THE TAIRUA SKATEPARK PROJECT

Tairua Skatepark Location Statement of Proposal

Deliberations Report

Figure 1: Incorrect Design Interpretation

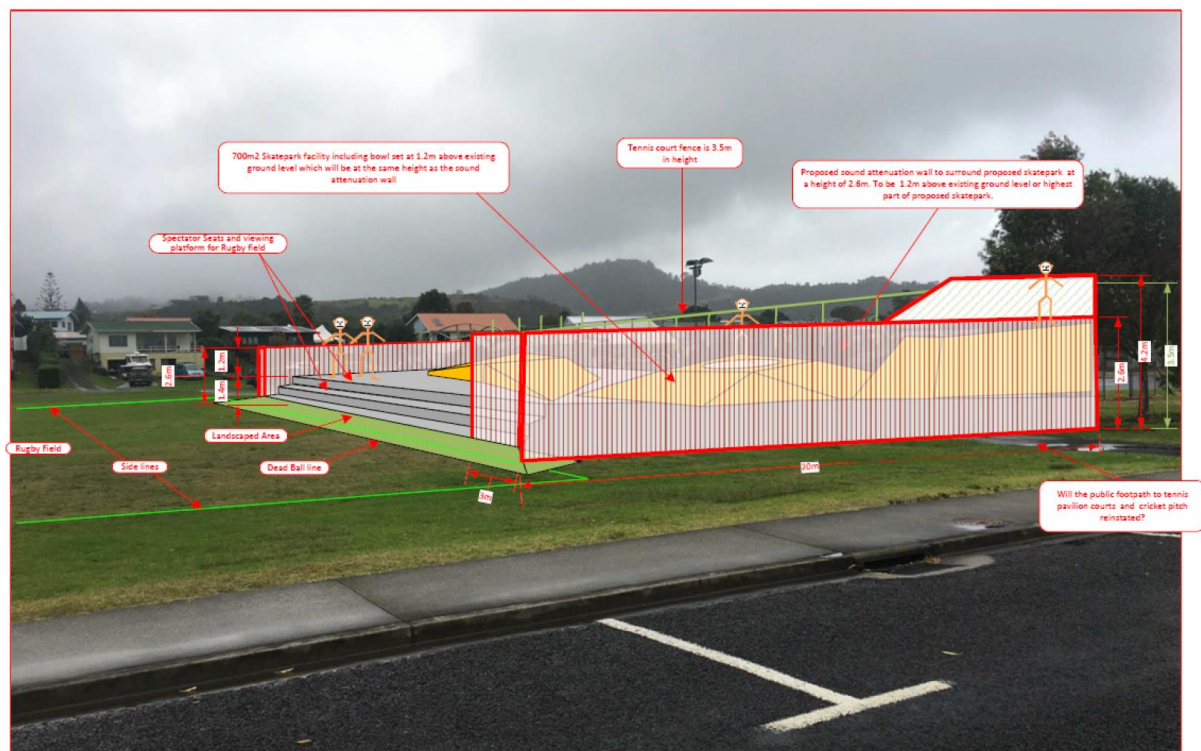
A number of submissions on the 'Statement of Proposal - Tairua Skatepark Proposed Location', make reference to, and/or specifically indicate an interpretation of the recommended acoustic barriers that is incorrect.

The recommendations from the AES report have been incorrectly interpreted to develop a design interpretation that has been circulated around the community and is included within some submissions. This design raises the skatepark 1.2m above ground level. From this height, the design then applies acoustic walls to a height extending up to 4.2m above ground level. One of the aspects of this design is shown in figure 1.

There is no indicated requirement for the skatepark ground level to be raised to 1.2m above the current ground level. The recommendation made by AES refers to a 1.2m high 'C' shaped acoustic

As clarified in section 3.3, the acoustic barriers featured in the inaccurate design representation are not part of the design response. Barriers like those would not comply with district planning requirements. Therefore, the CPTED assessment carried out by Veros remains accurate.

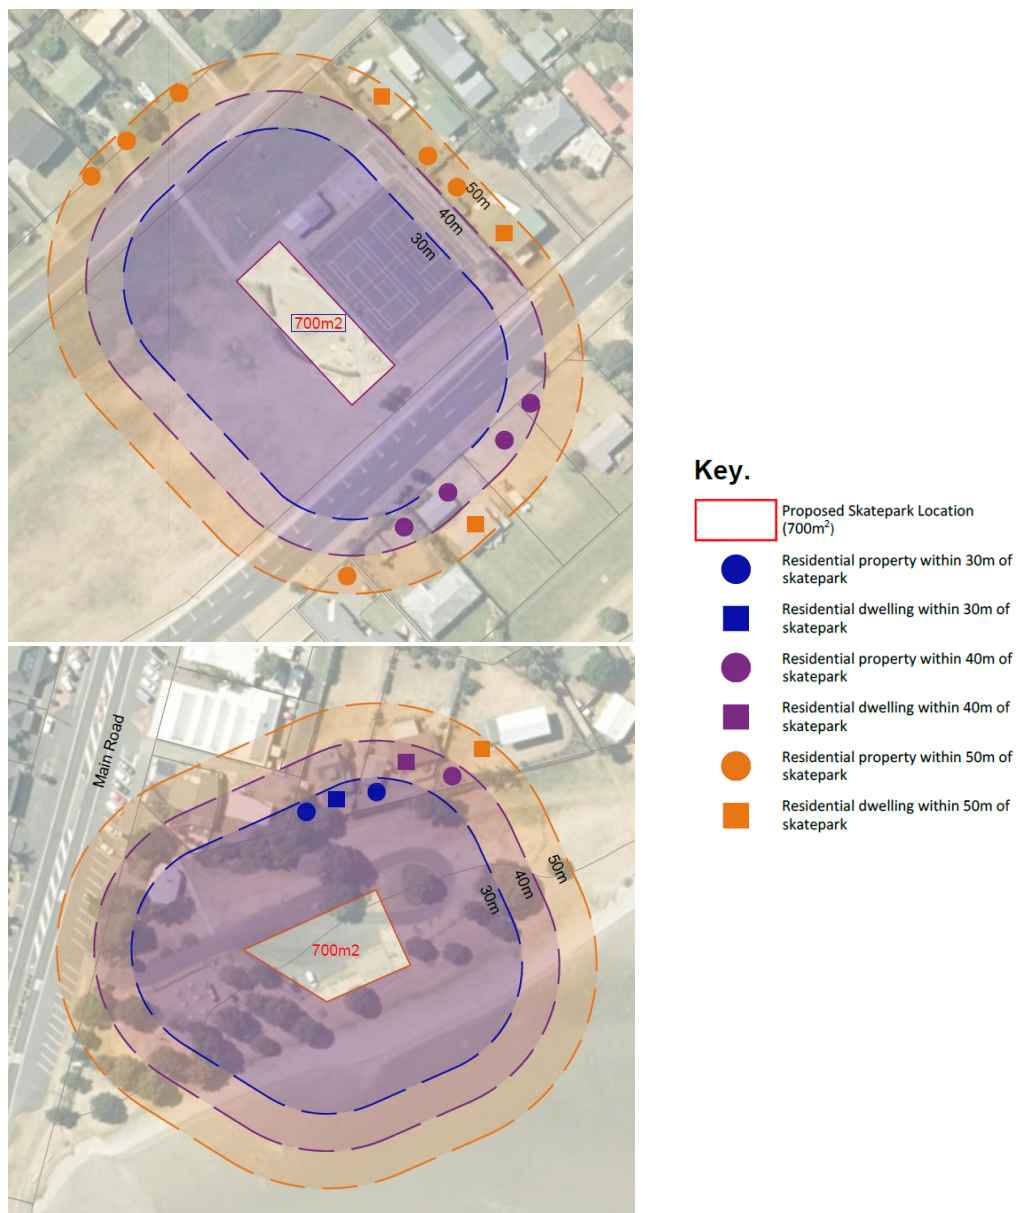
Supporting the statement of proposal at the February 8, 2022 TCDC meeting was the 'Site Selection Consolidated Report | Statement of Proposal Recommendation | January 2022'. In this report, the methodology used to observe and assess section 3. 'Location - Distance to Neighbours' of each location was not applied accurately. This led to the area setbacks being wider, and therefore including the total number of properties and dwellings count higher than the number of properties and dwellings within the actual setback ranges of 30m, 40m, and 50m from the proposed sites.

The Cory Park Domain and Pepe Reserve Location - Distance to Neighbours criteria has been reassessed, however, with the number of properties and dwellings within the setback distances reducing for both locations.

The MCA final score is not impacted and remains the same. Pepe Reserve 3. Cory Park Domain 2. Therefore, the overall score remains the same. See the reviewed setback images for Cory Park Domain and Pepe Reserve respectively below:
